FERGUSON TOWNSHIP PLANNING COMMISSION
Regular Meeting Agenda
Monday, December 12, 2022, 6:00 PM

1. MP Machinery and Testing at 2161 Sandy Drive Preliminary Land Development Plan

SUBJECT: MP Machinery and Testing at 2161 Sandy Drive Preliminary Land Development Plan

RE: MP Machinery and Testing Preliminary Land Development Plan

PROJECT NO:
21316
 DATE:
MAY 3, 2022
 SCALE: **N.T.S.** SHEET NO.: **10**

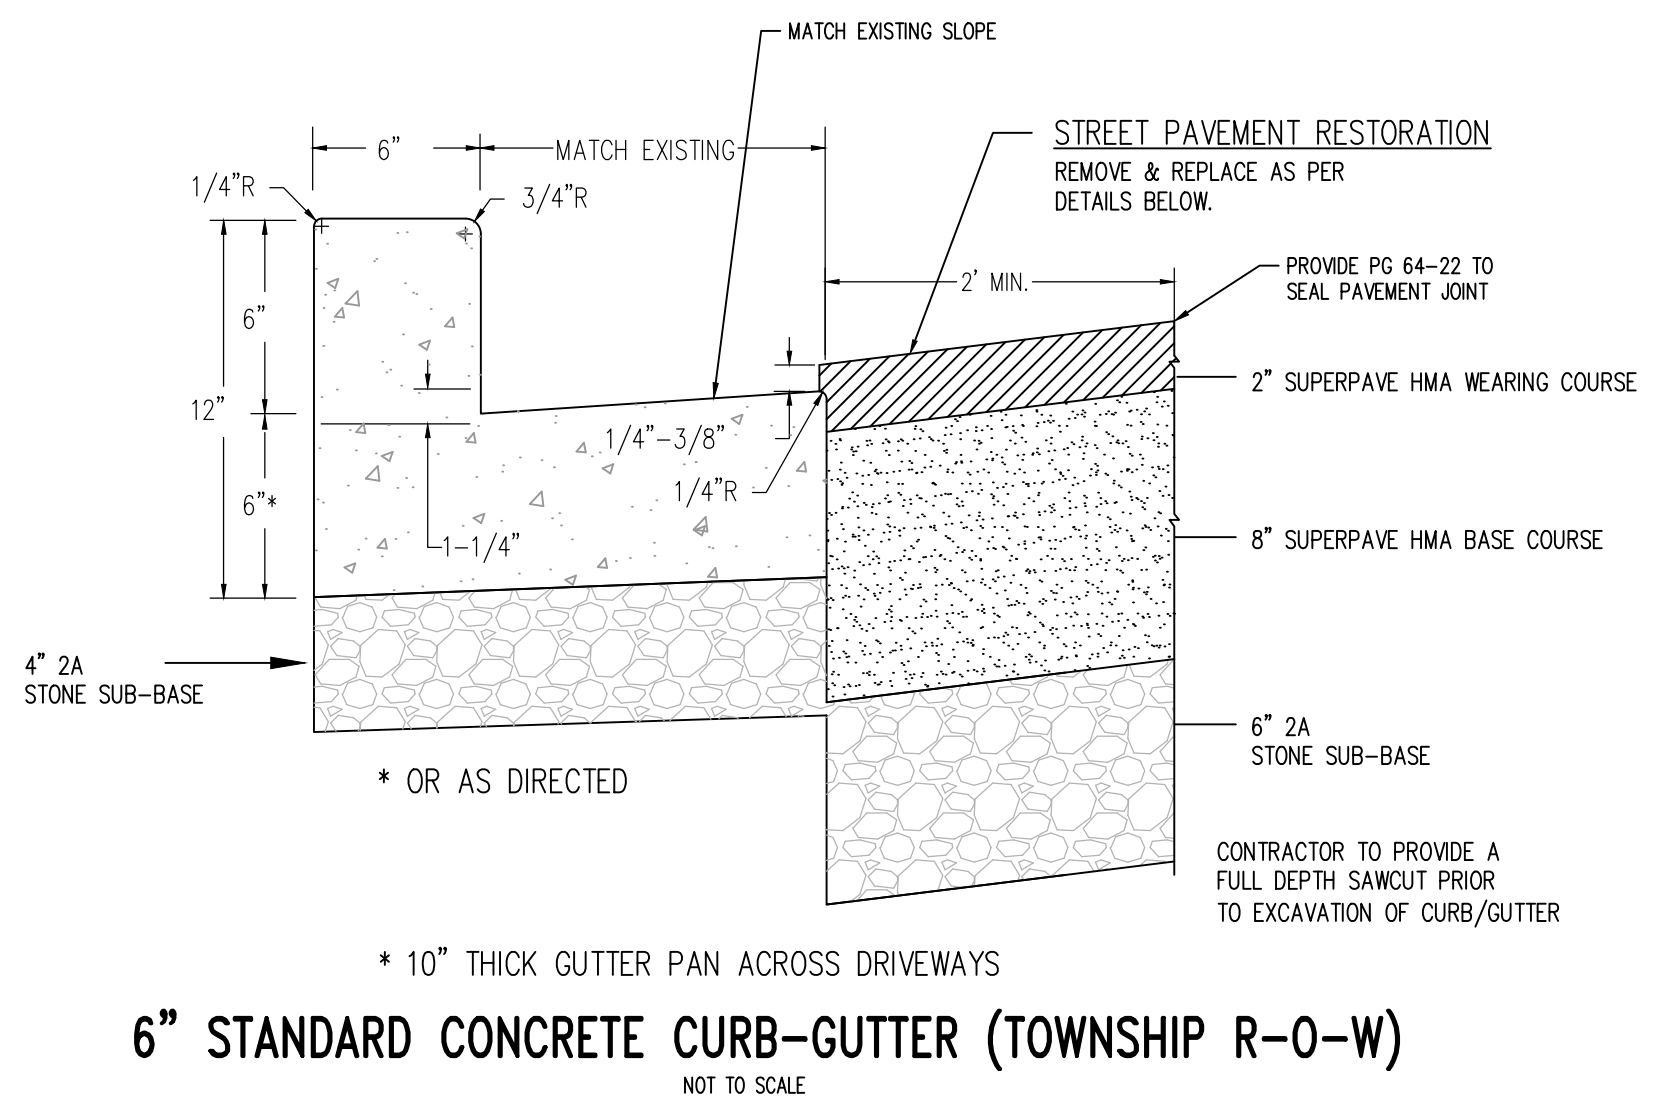
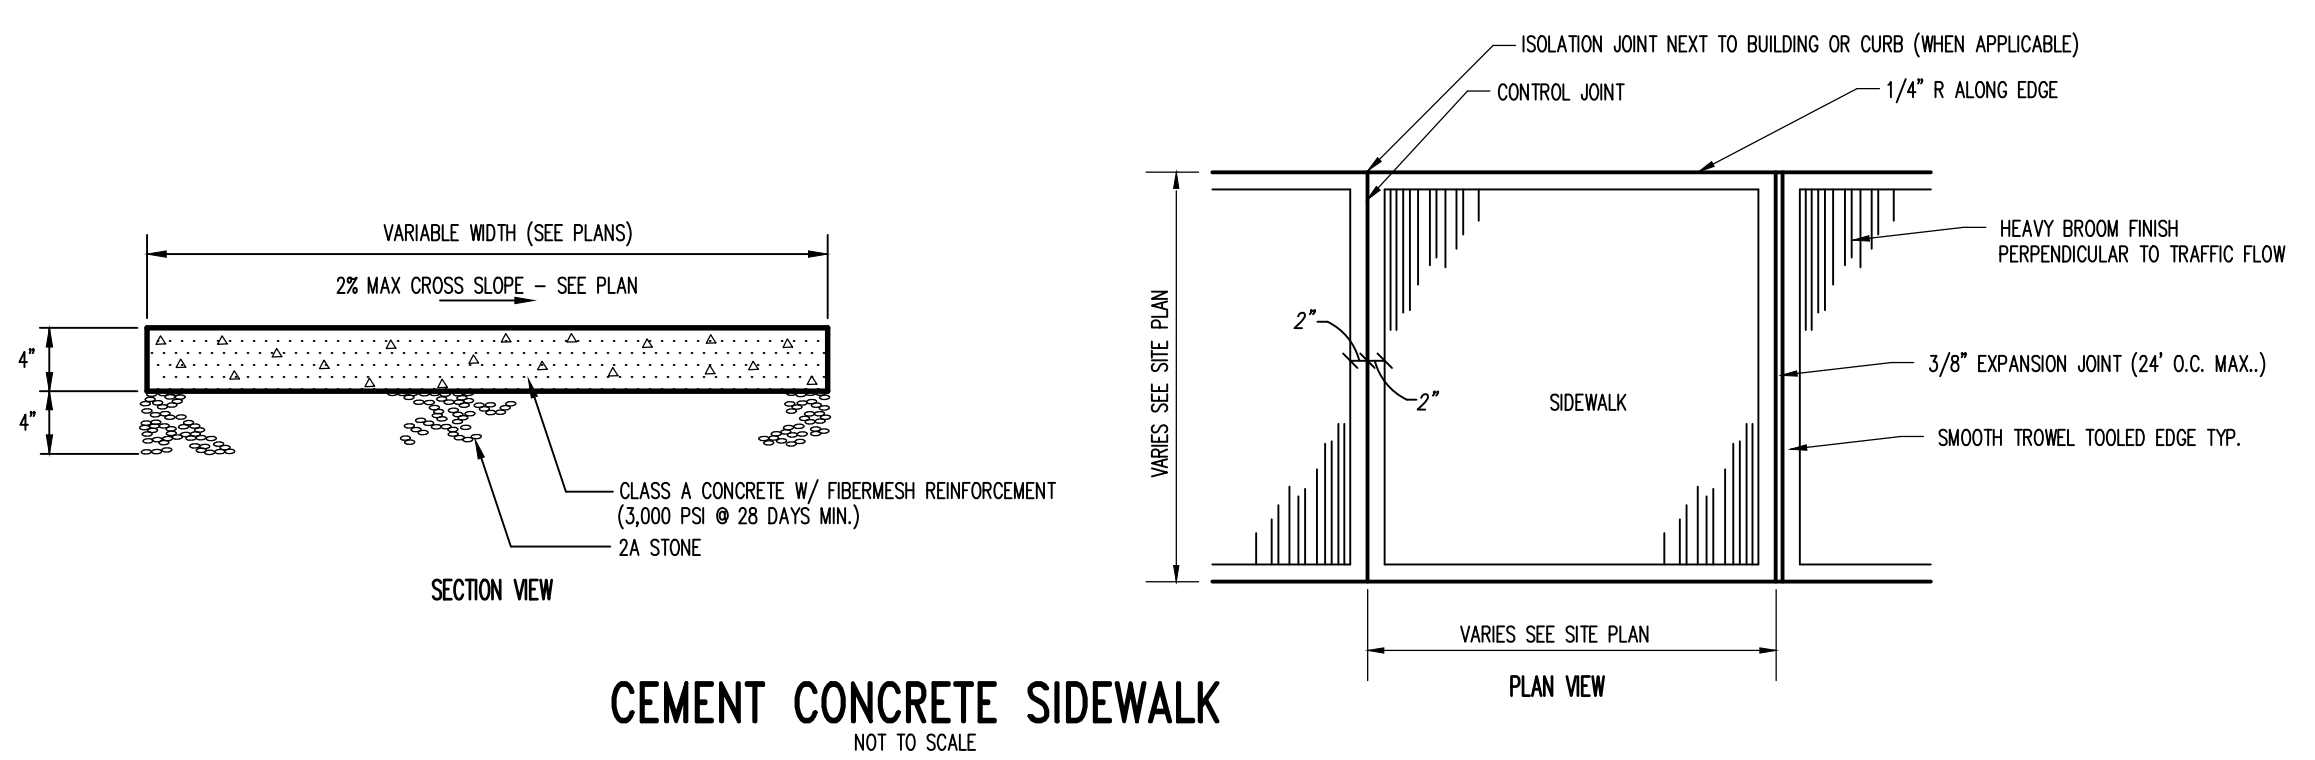
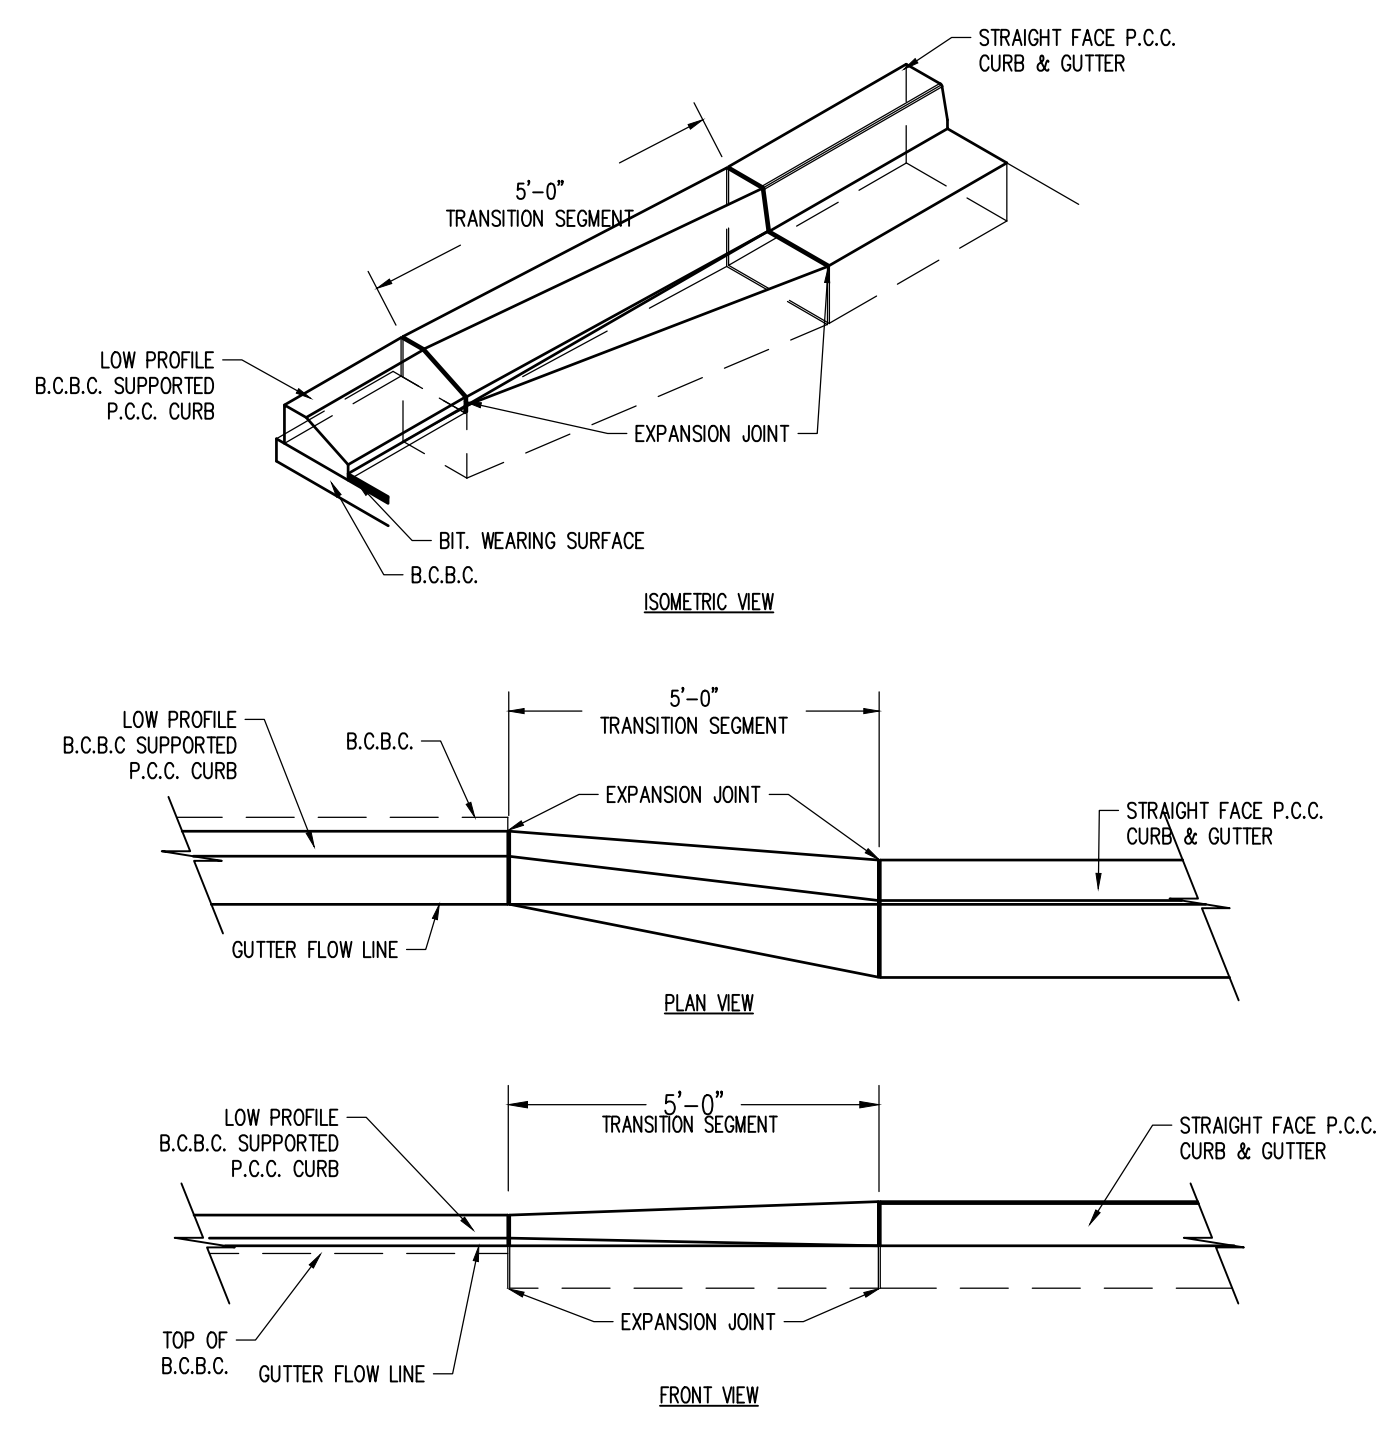
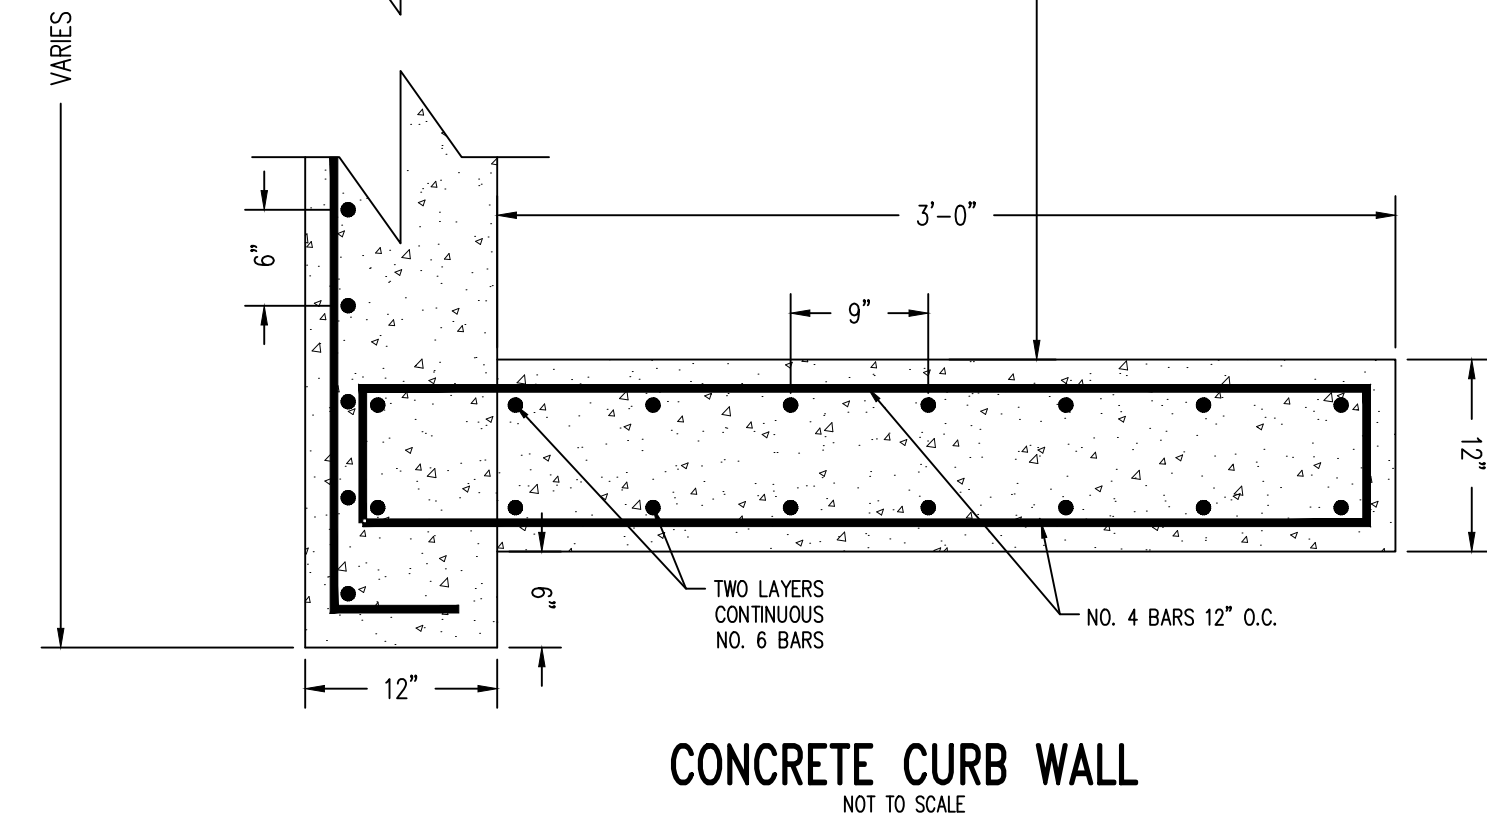
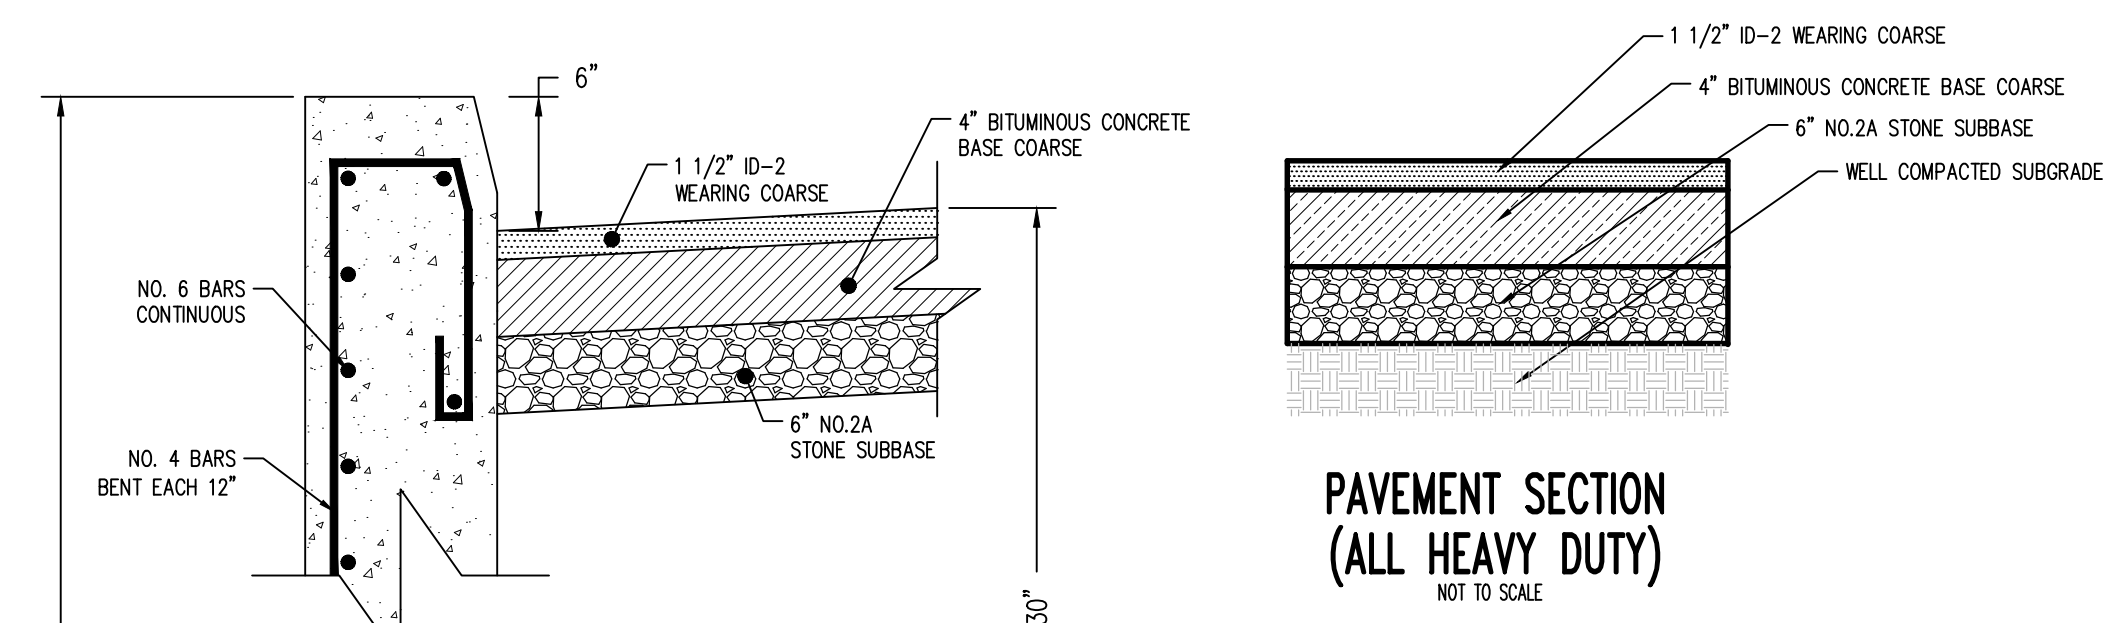
9. Please label the existing detail of Depressed Concrete Curb to be for handicap sidewalk ramp. Not resolved. The response indicates it is labeled, but the plan did not change. 11-28-22; not resolved. The response indicates it is labeled, but the label of the detail on sheet 10 did not change.
Updated. See Sheet 10; we added the (*)NOTE.

10. Please provide a detail for the depressed curb/gutter for driveway. Not resolved. I cannot locate a detail for depressed curb/gutter for the driveway on Sheet 9. 11-28-22; not resolved. The following items need corrected on both provided details for curb-gutter:

- a. The depressed curb should specify 1 ¼", not ¼".
Updated. Refer to Sheet 10.
 - b. Since the gutter pan cross slope was labeled to match existing, the specified slope of ½" per foot should be removed.
Updated. Refer to Sheet 10.

- c. Since the gutter pan width was labeled to match existing, the overall width of the curb and gutter should be removed.
Updated. Refer to Sheet 10.
11. Please provide a detail for the connection between the concrete curb/gutter and the driveway curb. Not resolved. I cannot locate a detail on Sheet 9. 11-2-22; not resolved. This requested detail is not on the plans. 11-28-22; not resolved. This requested detail is not on the plans. The detail would show how the driveway curb connects to the street curb in a monolithic manner.
Provided. Refer to the TRANSITION: EXTRUDED CURB TO STRAIGHT FACE CURB & GUTTER on Sheet 10.
